Subject: I-495 & I-270 Managed Lanes Study

Evidence of scientific fraud in FEIS traffic model

Evidence of Possible Scientific Fraud in Toll Lane Traffic Model

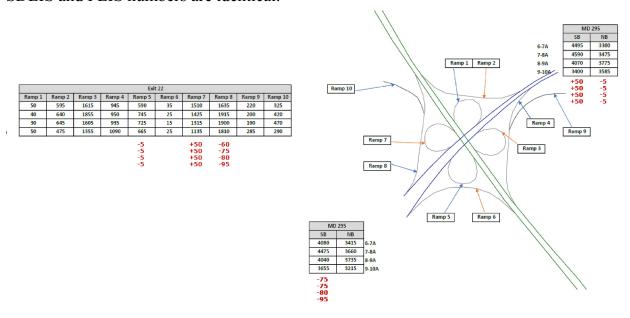
The Baltimore-Washington Parkway (MD 295) interchange provides a clear example of this. The figure shows evening rush-hour traffic volumes from the SDEIS modeling¹ with changes from SDEIS to FEIS listed beneath in red. Where there are no red numbers, the SDEIS and FEIS numbers are identical.

The change in traffic on northbound MD 295 outside the Beltway exactly matches the change in traffic entering from Ramp 3; there is no change in through traffic or on the other three connecting ramps. The change in southbound traffic approaching the Beltway exactly matches the change in traffic on ramp 7 onto the eastbound Beltway. The change

in southbound traffic beyond the interchange matches the change in traffic on Ramp 8 from the eastbound Beltway in 3 of 4 one-hour intervals; there is a 15-vehicle discrepancy in the 3:00-4:00 hour.
